Ltr pursuant to Para 50.59 of 10CFR50,
Request Change to Tech Specs (App A)
for License DPR-17 w/attached Figures
1 thru 7 for Nine Mile Island...

RE: Docket No. 50-220; License DPR-17

Pursuant to Paragraph 50.59 of 10 CFR Part 50, Niagara Mohawk Power Corporation proposes changes to Appendix A (Technical Specifications) of Provisional Operating License DPR-17 for the Nine Mile Point Nuclear Station.

FIGURE 7
FLOW CONTROLLER MALFUNCTION
(INCREASED FLOW)

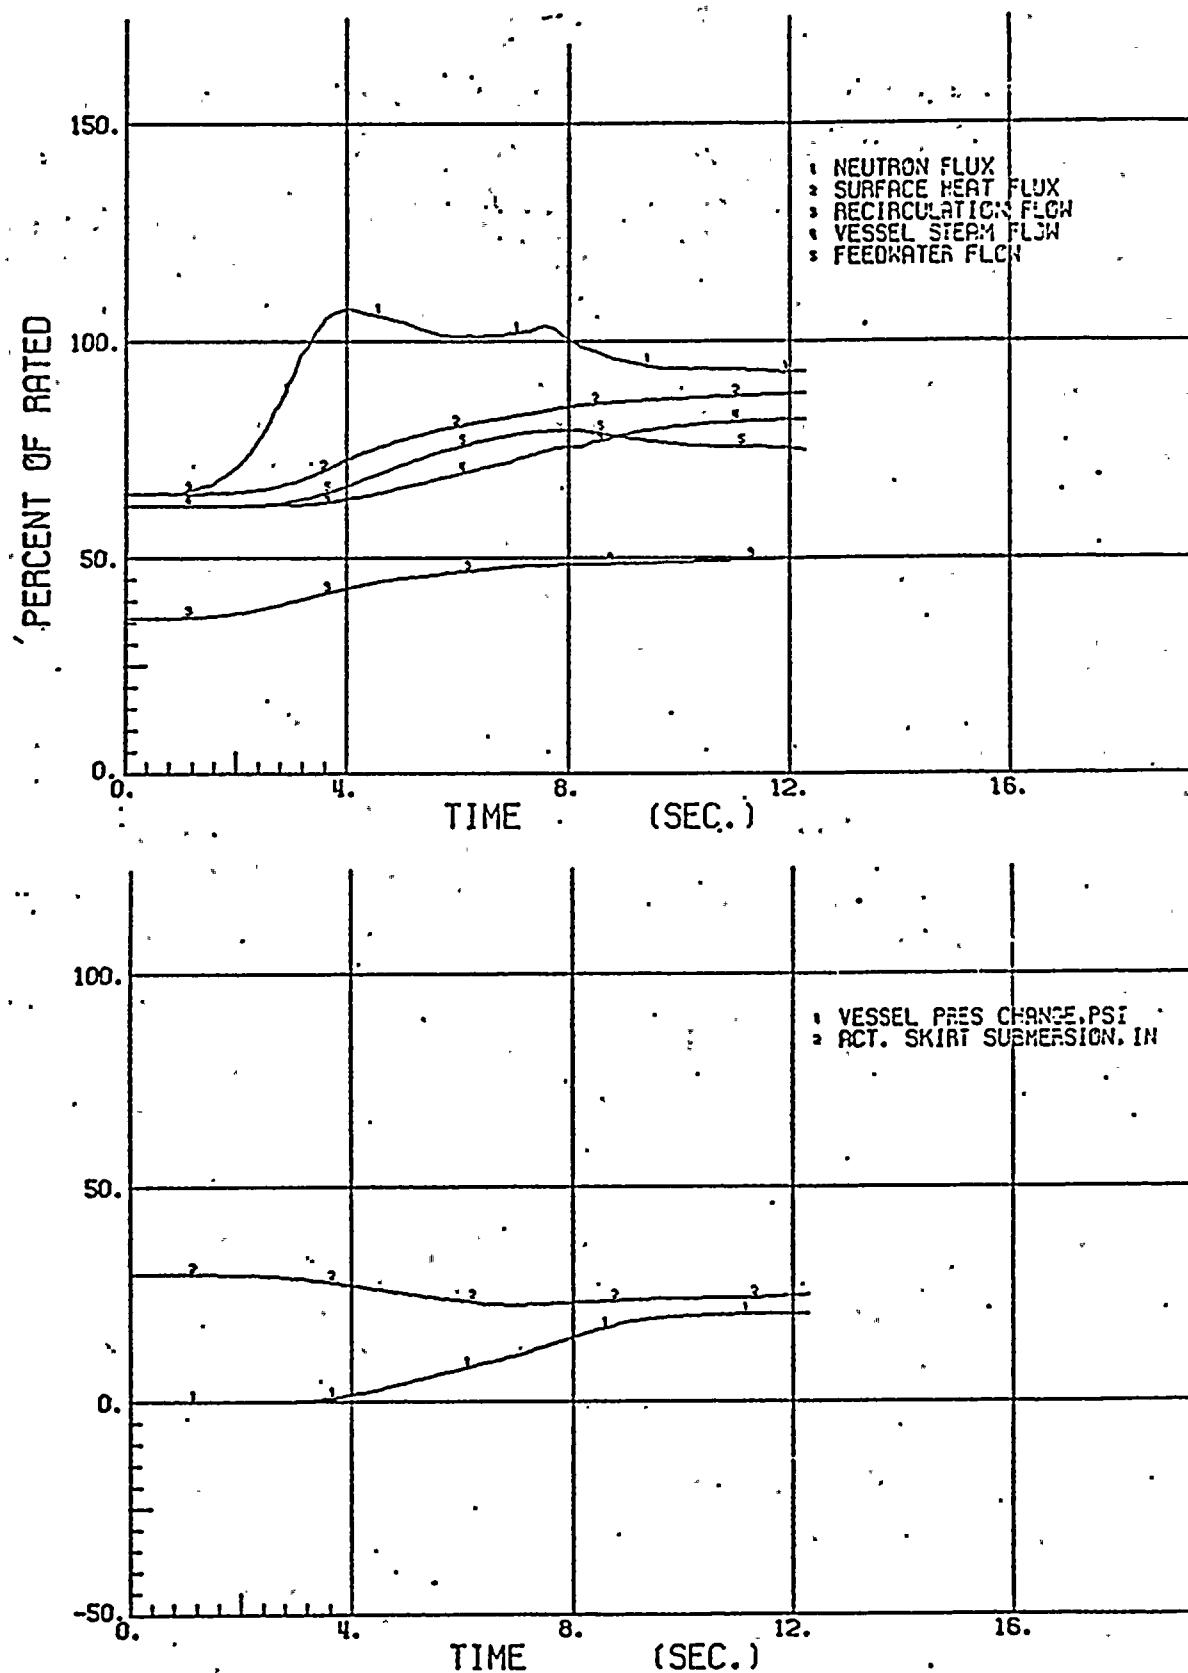
The transient resulting from this accident is shown in Figure 7. No scram trip level is reached during this transient.

The starting point for this transient analysis was about 54 percent of 1850 Mwt and 36 percent recirculation flow which is considered a typical low-power operating point. The malfunction in the one speed controller causes total recirculation flow to increase to about 48 percent within 9 seconds. Neutron flux leads the flow and peaks at about 89 percent within 4 seconds. A second peak of the same magnitude occurs at about 7.5 seconds as a result of increasing feedwater. Peak thermal power is essentially reached at about 12 seconds with a value of 73 percent of 1850 Mwt. The transient terminates at this time because of a model constraint. The transient is mild, not much more severe than the maneuver of running up in power on flow control. No thermal limits are approached during the transient. The flow in the loop in which the malfunction occurs increases rapidly to about 133.9 percent of rated loop flow. This flow increase from 36 percent to 133.9 percent occurs within 9 seconds.
